Project 711-D

Information technology - SCSI / ATA Translation (SAT)

Summary of Comments on SCSI / ATA Translation Standard

Figure 1 — SCSI document relationships

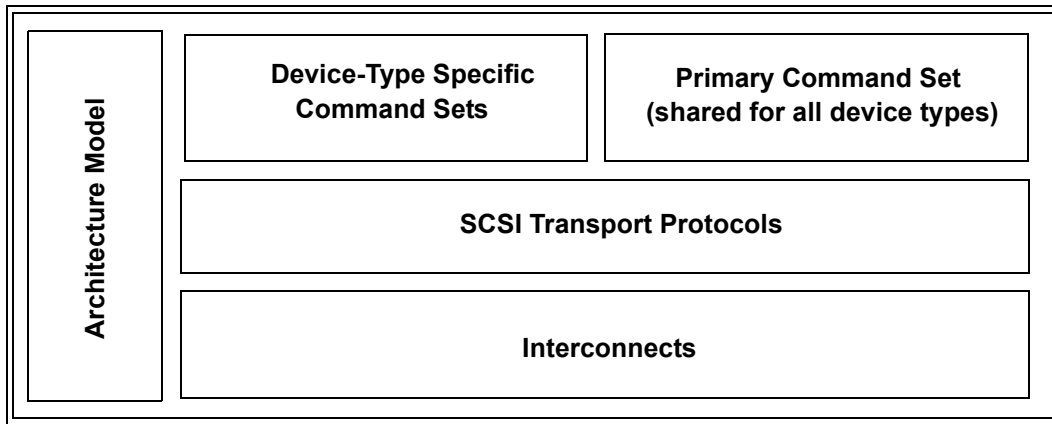
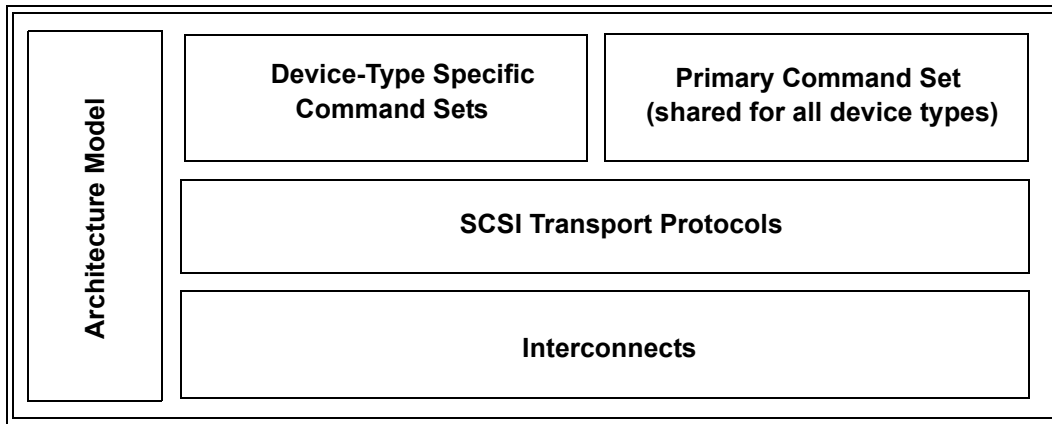
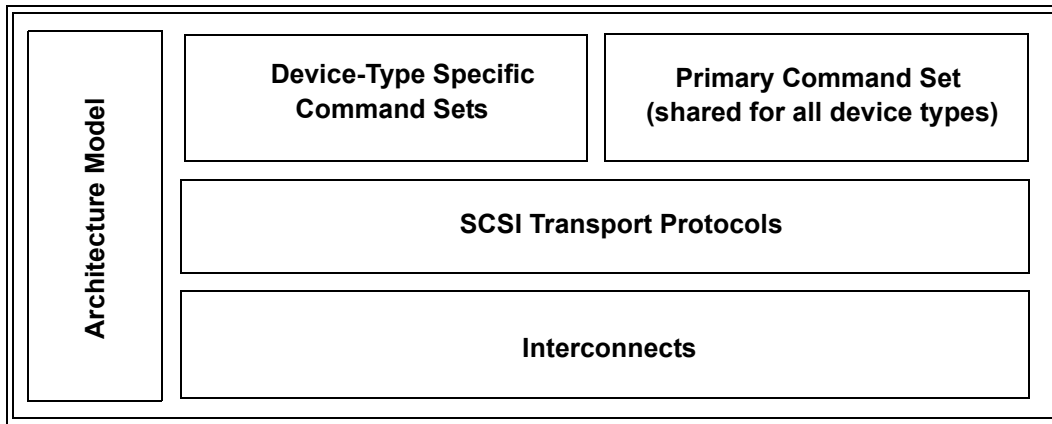
T first sentence after figure 1
This statement is obsolete and should be changed to something like << The term SCSI is used wherever it is not necessary to distinguish between the different SCSI standards.>>

Figure 2 — ATA document structure

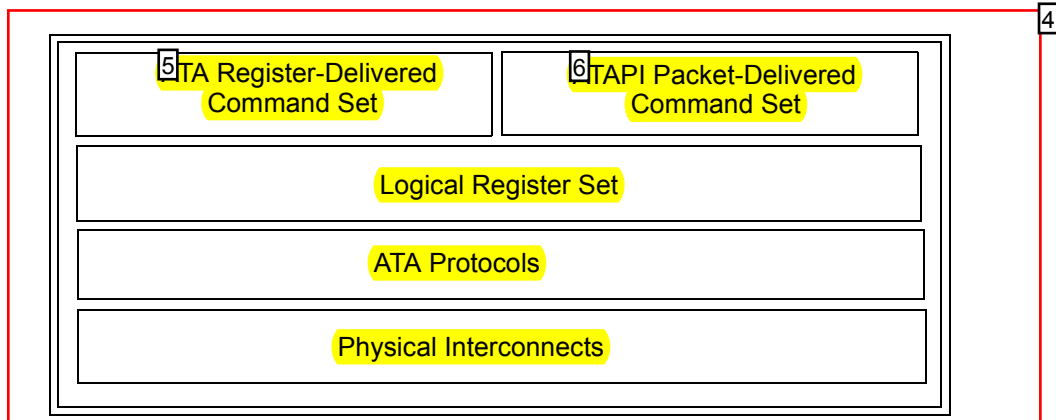
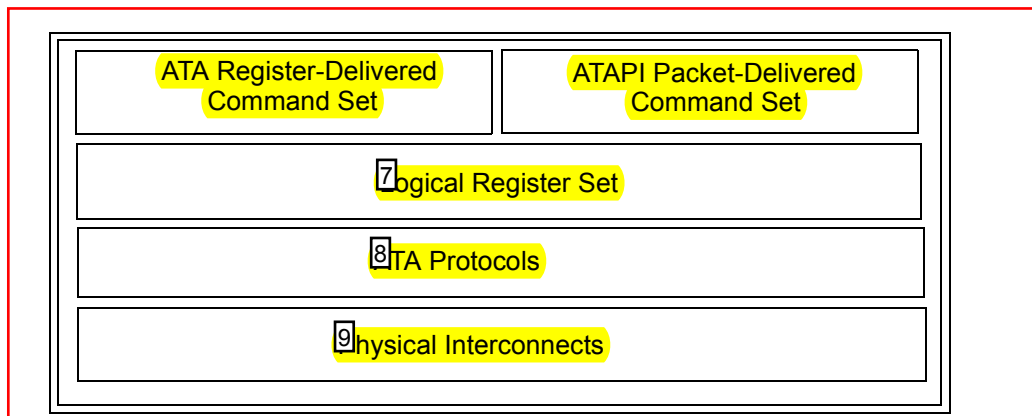
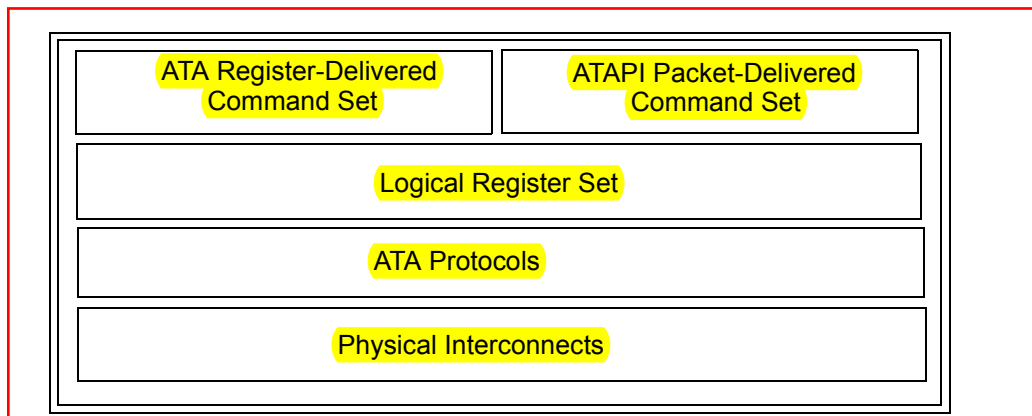
T 1 Scope, the line just before figure-2
Change "ATA/ATAPI-7" to "ATA8".

T Remove the period below the words "Figure 2 shows ..." and above the actual Figure 2.

Figure-2 - ATA document structure
Replace this figure with one showing the ATA8 documents as follows (ignore italics):
"ATA AT Attachment-8 ATA/ATAPI Command Set (ATA8-ACS)
Archi- AT Attachment-8 AT Attachment-8 Serial ATA
tecture Parallel Transport Serial Transport Revision 2.5
Model (i.e., ATA8-APT) (i.e., ATA8-AST) (i.e., SAT -2.5)
ATA8-AAM)"

T In Figure 2
change
"ATA Register-Delivered Command Set"
to
"ATA register delivered command set"

T In Figure 2
change
"ATAPI Packet-Delivered Command Set"
to
"ATAPI packet delivered command set"
RESOLUTION: s/b "ATAPI packet delivered command sets", for consistency with ATA8-ACS.

T This layer doesn't appear in ATA/ATAPI-7
Figure 2
change
"Logical Register Set"
to
"ATA logical register set"
RESOLUTION: Delete the box containing "Logical Register Set" as it doesn't appear in ATA8-ACS.

T Figure 2
change
"ATA Protocols"
to
"ATA Transport Protocols"

T Figure 2
change
"Physical Interconnects"
to
"ATA physical interconnects"

Figure 3 — SCSI/ATA translation document role

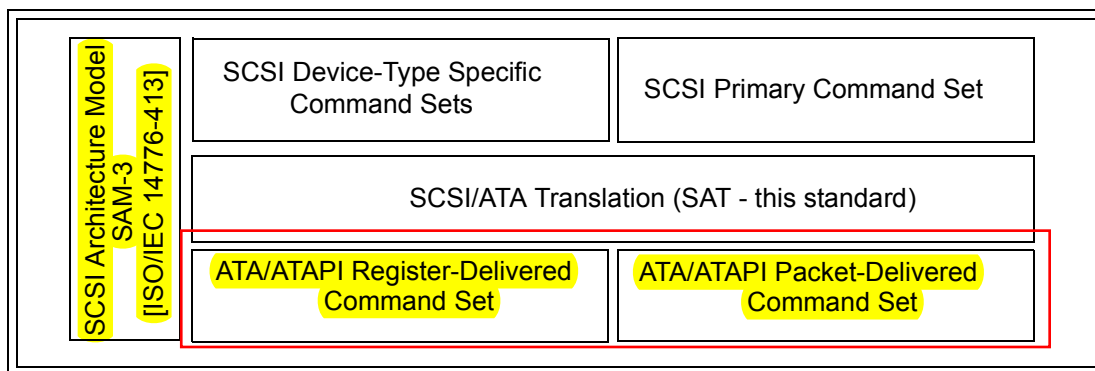
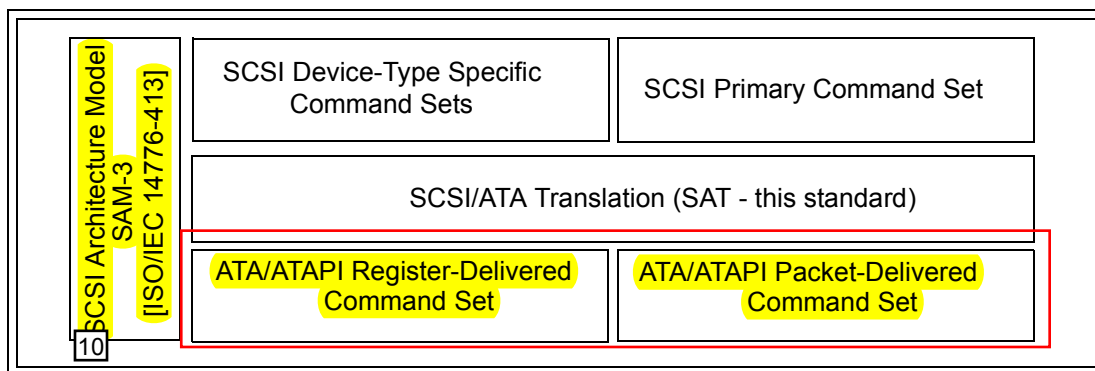
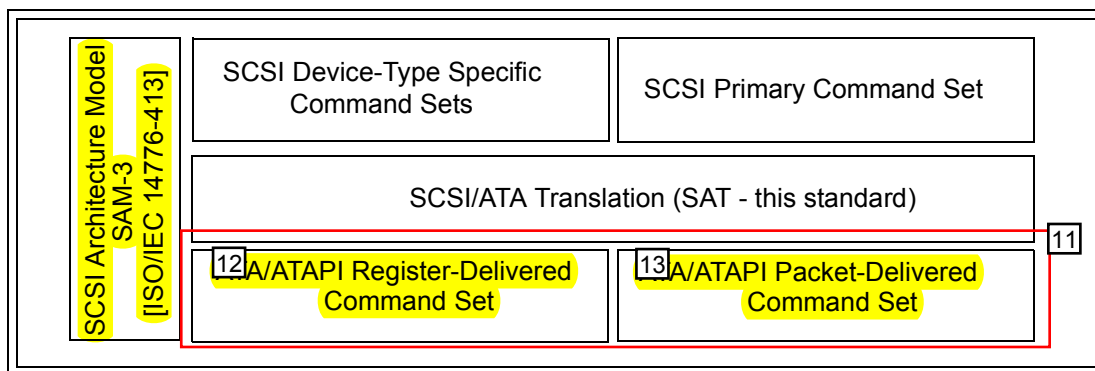
T In Figure 3, remove
"SAM-3
[ISO/IEC 14776-413]"

Figure-3, bottom two boxes:

Figure 4 — SATL functional protocol reference model

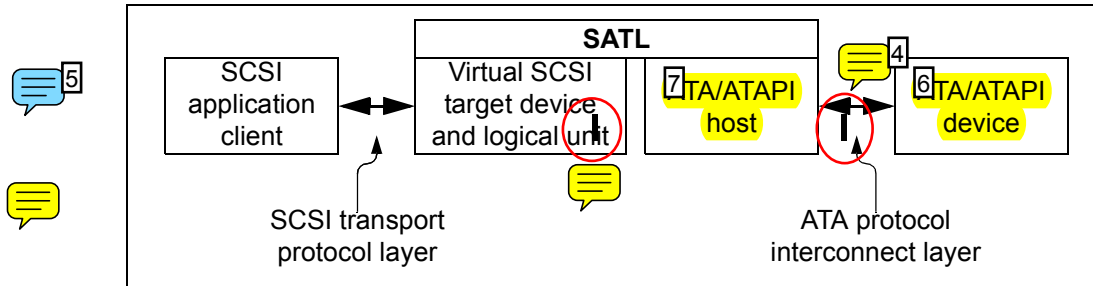
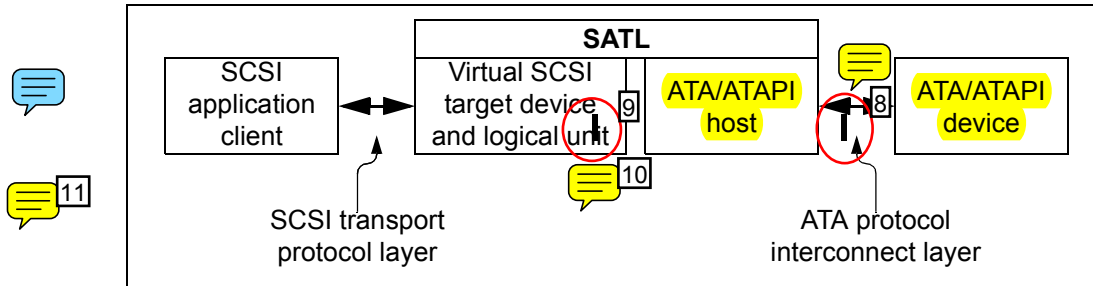
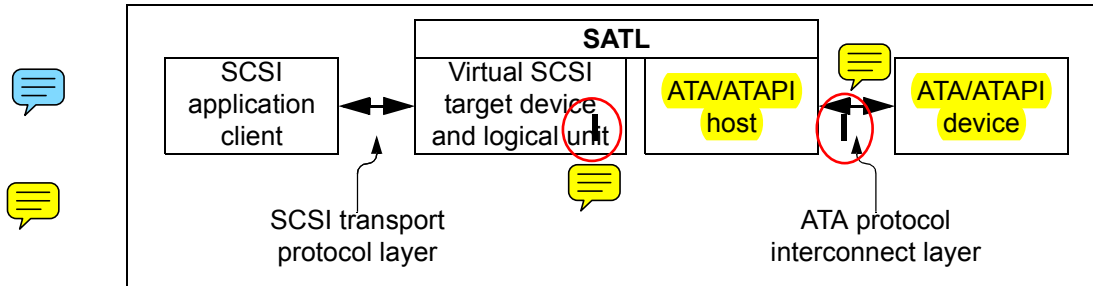
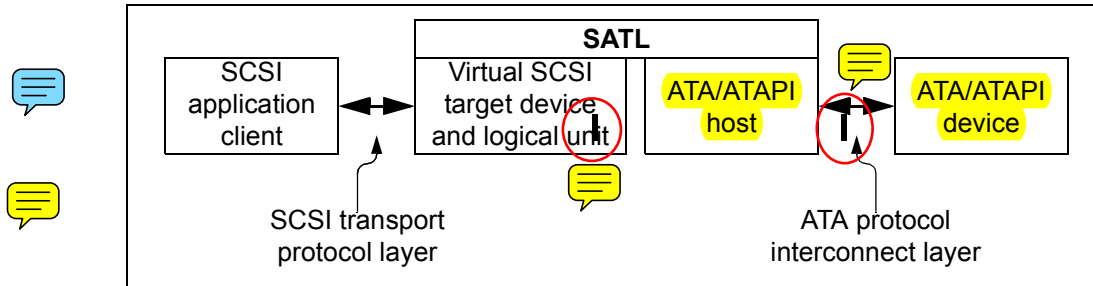
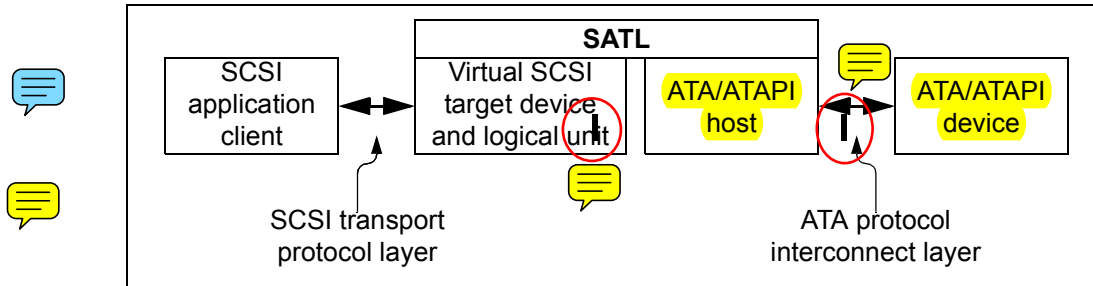
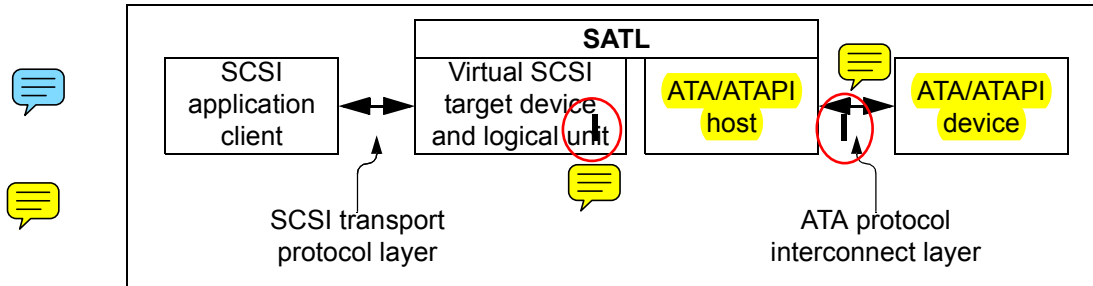
Figure 4 - SAT functional protocol reference model
change
"ATA/ATAPI host"
to
"ATA host"

5.1
figure 4
remove extra lines in figure

Figure 4
This figure has some strange fat lines in it that need to be removed.

1. Remove what look like change bars in Figure 4
2. Change "logical unit" to "logical unit(s)"
3. Change "ATA protocol interconnect layer" to "ATA transport protocol interconnect layer"

Change the figure title to: "Figure 4 - Example of a SATL between a SCSI application client and an ATA or ATAPI device", fix change bars, and the change in item-3 as well.

Figure 5 — Identification descriptors included by a SATL in an ATA host

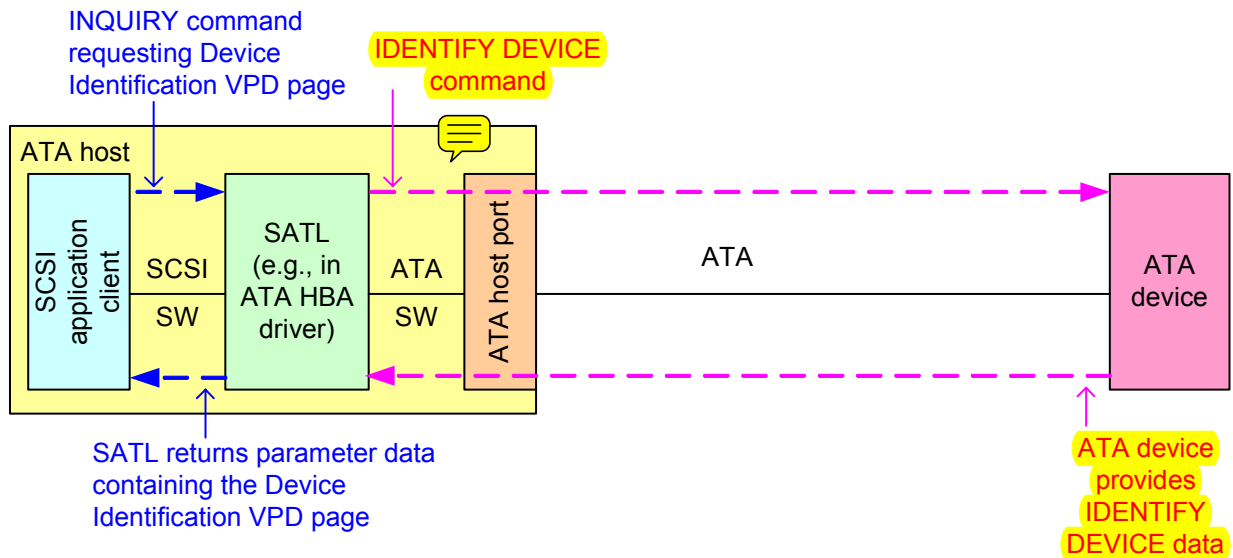
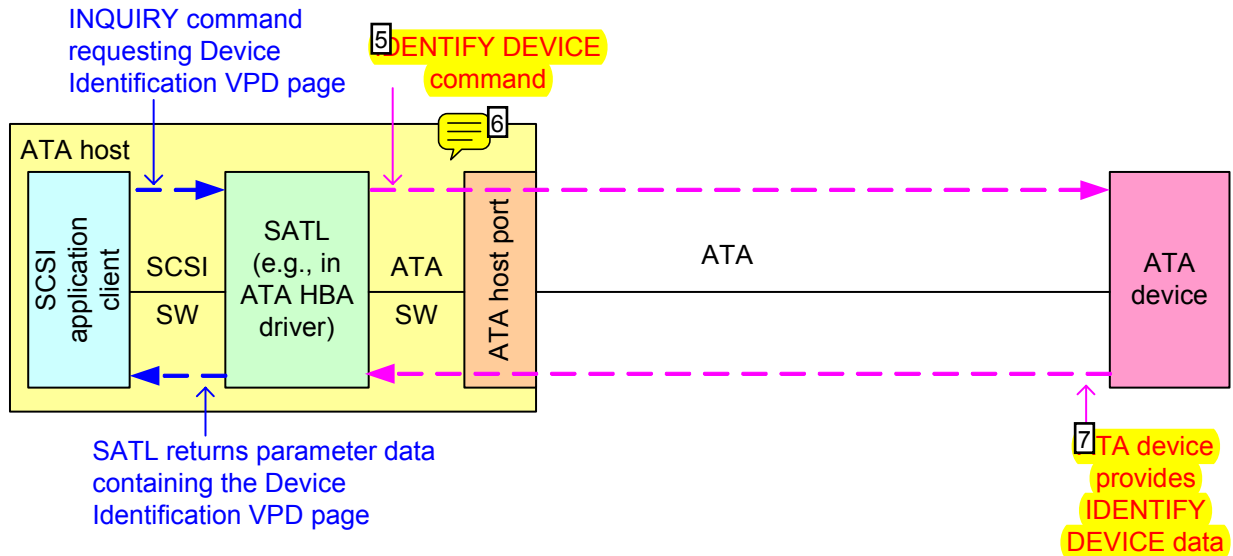
T In **Figure 5 — Identification descriptors included by a SATL in an ATA host**
change
"IDENTIFY DEVICE command"
to
"ATA IDENTIFY DEVICE command"

T In **Figure 5 — Identification descriptors included by a SATL in an ATA host**
change
"ATA device provides IDENTIFY DEVICE data"
to
"ATA device returns ATA IDENTIFY DEVICE data"

Figure 6 — Identification descriptors included by a SATL in a SAS initiator device

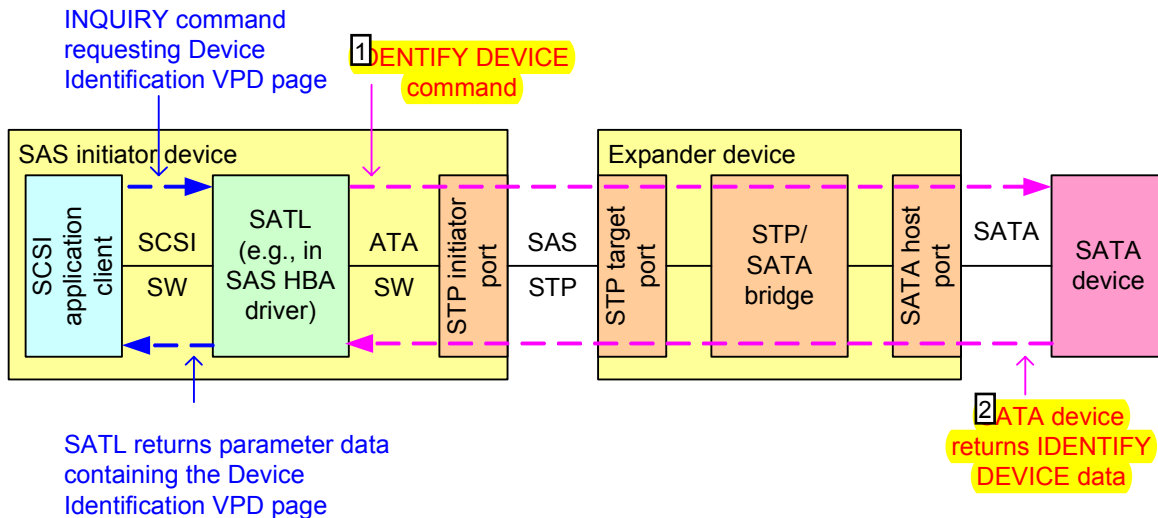
T In **Figure 6 — Identification descriptors included by a SATL in a SAS initiator device**

T In **Figure 6 — Identification descriptors included by a SATL in a SAS initiator device**

Figure 7 — Identification descriptors included by a SATL in a SCSI to ATA protocol bridge

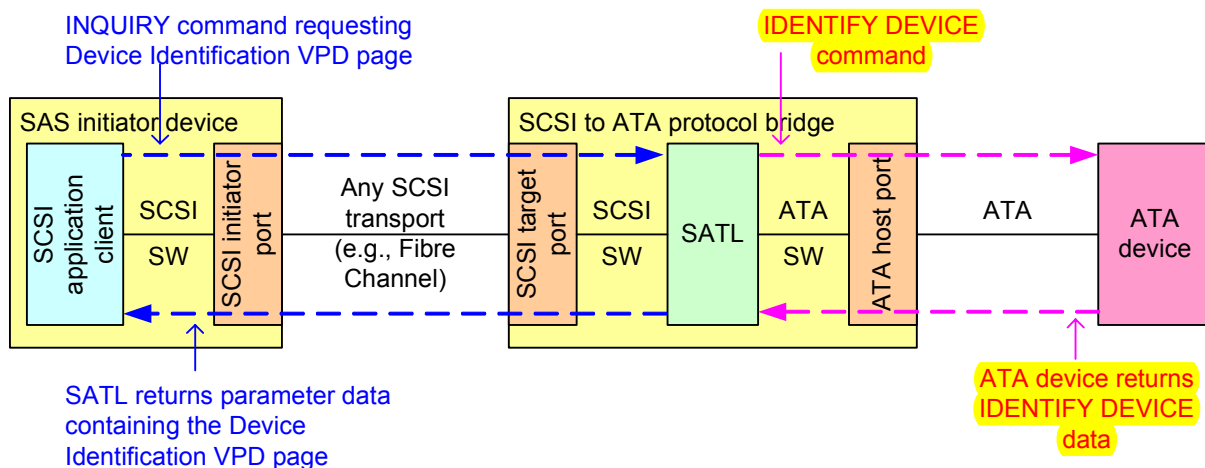
T In **Figure 7 — Identification descriptors included by a SATL in a SCSI to ATA protocol bridge**
change
"IDENTIFY DEVICE command"
to
"ATA IDENTIFY DEVICE command"

T In **Figure 7 — Identification descriptors included by a SATL in a SCSI to ATA protocol bridge**
change
"ATA device returns IDENTIFY DEVICE data"
to
"ATA device returns ATA IDENTIFY DEVICE data"
